Amendment Dated: January 11, 2007

Reply to Office Action of: October 11, 2006

Amendments to the Drawings:

Application No.: 10/073,804
Response to Office Action Dated: October 11,
ANNOTATED REPLACEMENT SHEET October 11, 2006

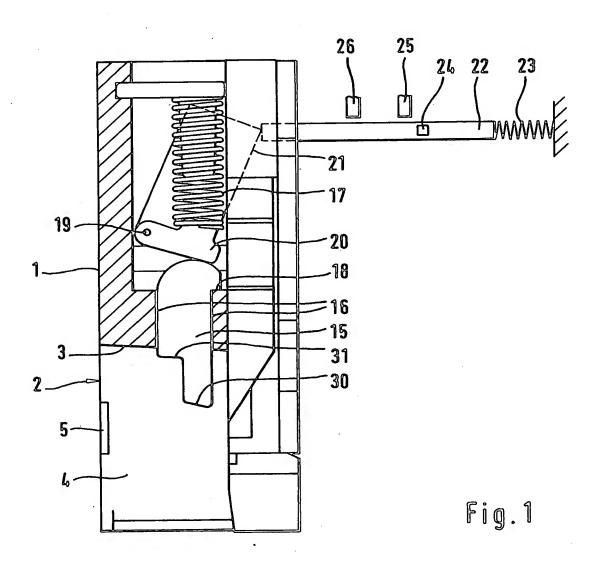
Regarding the Examiner's objection under 37 CFR §1.83(a), it is submitted that the drawings do show the features specified in the claims. Figure 1 shows the position of the sensor 15 in the absence of a lock; the first sensing position. Figure 2 shows the position of the sensor 15 in the presence of a lock 6; the second sensing position, and Figure 3 shows the sensor 15 and lock 6 in the third sensing position, wherein the band has been inserted into the lock. Thus the features: lock, first sensing position, second sensing position, and third sensing position, are clearly shown in the drawings. Claims 7 and 15-18 relating to the "fixing clips" have been canceled. It is submitted that each and every feature of the invention now specified in the claims is clearly shown in the drawings.

Application No.: 10/073,804
Response to Office Action Dated: October 11, 2006
ANNOTATED REPLACEMENT SHEET

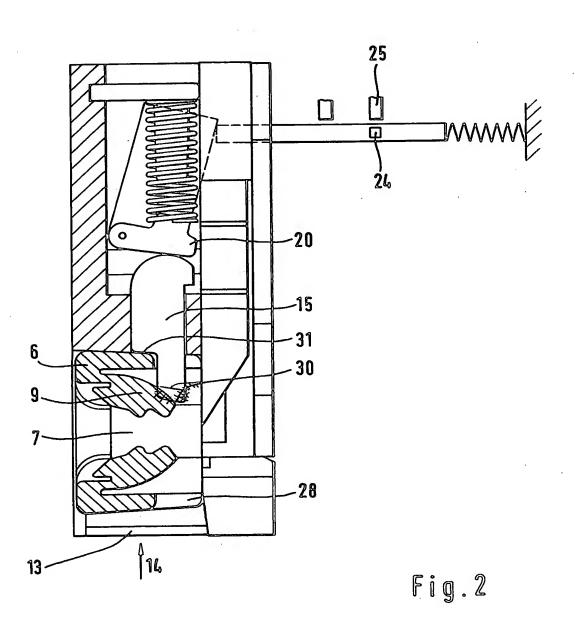
Figure 2 has been amended to show the proper position of the sensor 15 in relationship to the lock 6. Figure 3 has been amended to include the reference numeral 35.
